# Access Compliance Report Public Rights-of-Way (Curb Ramps)

Main Street: ROANOKE\_DR Cross Street: CHARDONNAY\_DR Location: SE

ADA ID: RPAT211103135630 Ramp Type: Type 4 - Parallel Initial Pass/Fail: Fail Overall Compliance: No Severity Score: 32

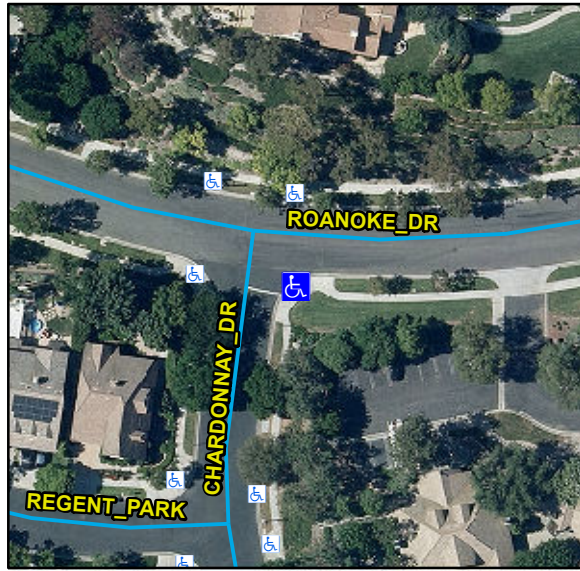
R204.3, R304.3.2, R304.5.3, STD 1115

| Compliance | Description                   | Data       | Compliance | Description                   | Data |
|------------|-------------------------------|------------|------------|-------------------------------|------|
| No         | Ramp Run Slope LT (%)         | 15.4       | No         | Ramp Run Slope RT (%)         | 9.2  |
| No         | Ramp Cross Slope LT (%)       | 3.3        | Yes        | Ramp Cross Slope RT (%)       | 1.1  |

Remove & Replace Curb Ramp With Two New Directional Ramps or Equivalent.
